From: Jamie Donaldson
Sent: Wednesday, August 7, 2024 9:52 AM
To: 'christina@varitonearchitecture.com'
Subject: RE: 2410 Mission Street SE, Incomplete Letter
Attachments: Incomplete Letter-markup.pdf

LAND USE APPLICATION - COMPLETENESS REVIEW

Subject Property:	2410 Mission Street SE
Reference Number:	24-108775-PLN
Application Type:	Class 3 Site Plan Review Modification
Date Application Accepted:	April 22, 2024
Applicant:	Russell Schutte russell@varitonearchitecture.com
Contact:	Christina Larson christina@varitonearchitecture.com

SITE LANDSCAPING LEGEND

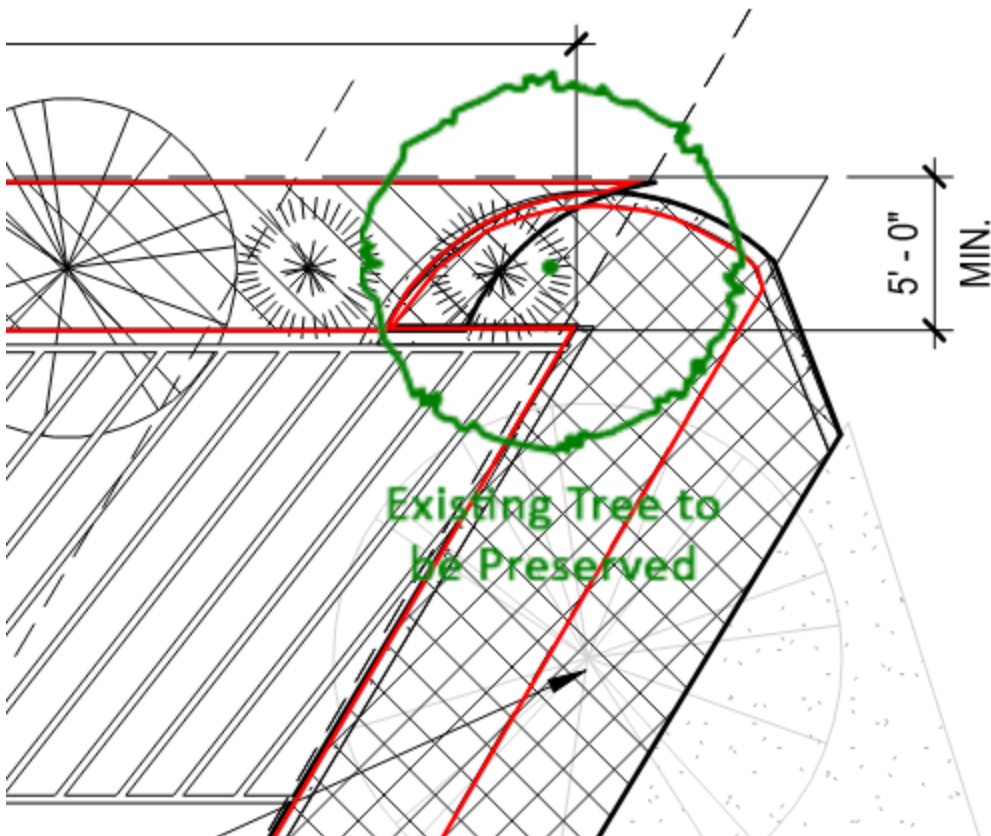
Please also note that the square footage for landscaping does not still not appear to be accurate. For one, the total size of the site (.47 acres) is a bit larger at 20,473 square feet, per Marion County records. Second, the planter area along Mission Street still appears to be counting portions that are in the right-of-way, which do not count towards on-site landscaping and lowers the amount to about 2,976 square feet provided on site, or 14.53%.

EXISTING SITE 20,298 SF **20,473**
LANDSCAPING 3,286 SF (16.0%) TOTAL **2,976 = 14.53%**
480 787 SF @ MISSION STREET
983 993 SF @ WEST SIDE OF LOT
114+64+75=254 246 SF @ PATIO AREAS
1260 1,260 SF @ PARKING
157 Pu REQUIRED PROPOSE PU'S
1 Mature tree (E) to remain 15
9 Shade Trees 90
1 Evergreen 5
32 Medium shrubs 32
832 sq ft of ground cover 16
Total PU 158

However, I am confused whether the northeast portion of the curb is being removed as it is not show on the plans, or if it will remain and there is slightly more landscaping in that area to count:

Please clarify what will happen with this curb so that I can adjust the landscaping total appropriately. While 14.53% is close, I may need to add a condition of approval to get us closer to the 15%, or the addition of plant units. Please also note that there was a condition of approval to save the tree in the northwest corner, which appears in the wrong location on the plans; however, this will not hold up completeness.
